# Author's response to the revision of hess-2022-330

## Editor Comment

## RC1: 'Comment on hess-2022-330'

**Figure 1.** Profile A-A' from the geological models V0 – layer model (a), V0 – voxel model, (b) V1 – voxel model (c), and V2 – voxel model (d).

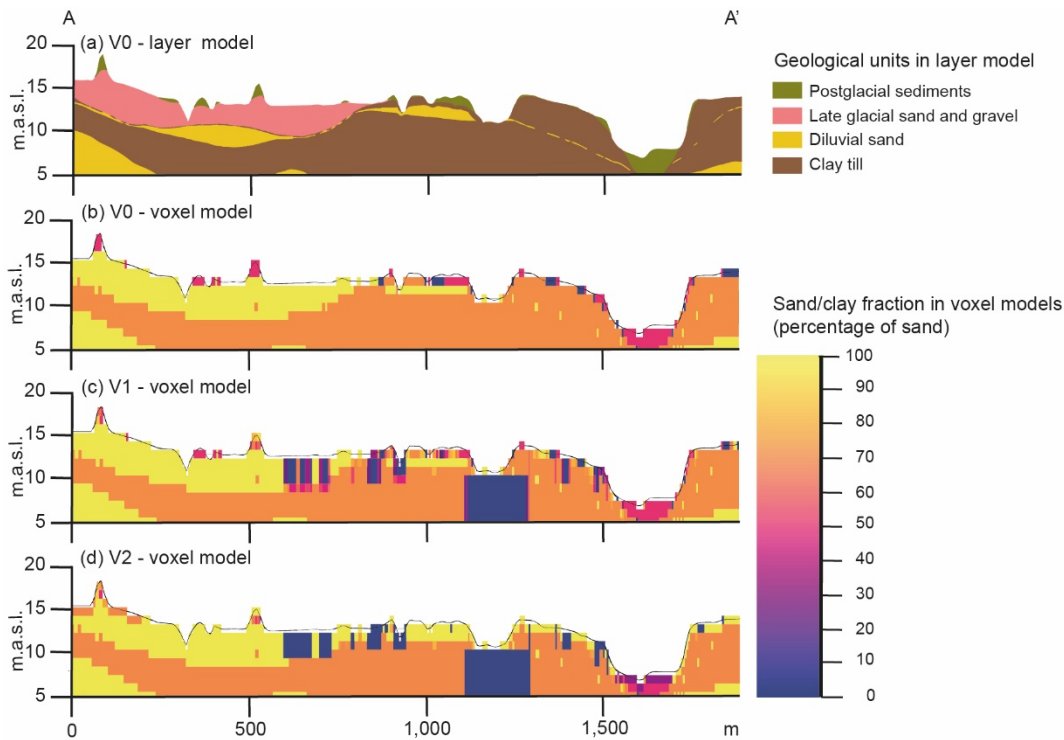
Fig. 4: Refrain from using a rainbow colour scale as it could misrepresent data due to its non-linear change in hue.

AR2.9: We have changed the color scale to be both a perceptually uniform scale and color-blind friendly.

The color of the figure (page 18, lines 438-440) has been changed as shown below. Due to a new figure in the manuscript the figure number has been changed from figure 4 to figure 5:

**Figure 2.** Percentage of the sand/clay fractions of the total volume of the geological voxel models V0, V1, and V2. Note that the sand/clay fractions 0.6-0.7 and 0.9-1.0, respectively take up about 37 % and 56 % in all models, and plot beyond the range of the y-axis.

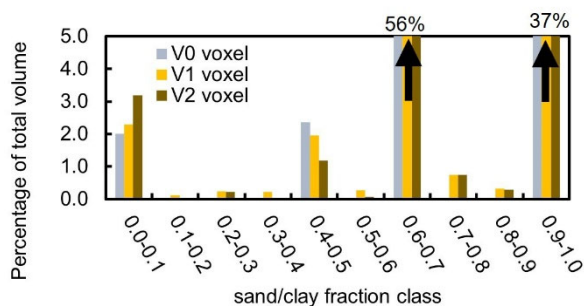
Fig 5: “56%” instead of “57%” in the bar plot

AR2.10: Thank you for pointing out the inconsistency in the text and the numbers in Fig. 5. The value has been corrected in the figure.

The figure (page 19, line 441-444) has been changed as shown below. Due to a new figure in manuscript the figure number have been changed from figure 5 to figure 6:

**Figure 3. Illustration of the model setup for the hydrological models**

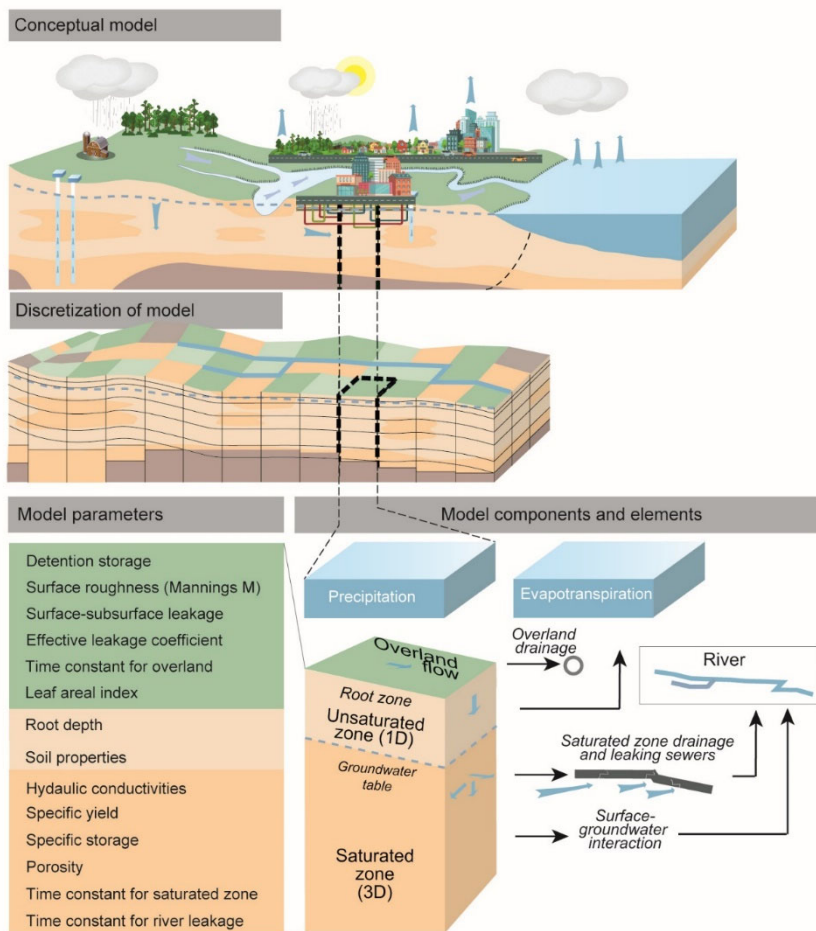
- P8 214-220 – Why the SHE model was chosen here? We can understand that it is the model used by the research team, but could the authors argue why this model is appropriate to do this study? Are there any equivalent modelling tools/methods that could have been considered for this type of modelling study? Is SHE model the only one that allows to achieve the objectives of this study?

Then, the methods section could have been improved with a graphical scheme helping the reader to understand the chosen parametrizations. This is especially needed in the 3.2.2 paragraph, because the list of the presentation of the parametrization and boundary conditions is quite long, and a scheme would be more efficient and more easy for the reader.

*We acknowledge that the manuscript lacks an argumentation for the choice of model code. In the revised version of the manuscript, we have elaborated on this at the beginning of section 3.2 Hydrological models. Generally, the section has been modified substantially after receiving the comments given to us by reviewer RC3. We have added an argumentation for the choice of model and a schematic figure of the hydrological model.*

In the revised manuscript page 10-12, lines 250-288 the following text in section 3.2 Hydrological models have been altered a new figure have been added:
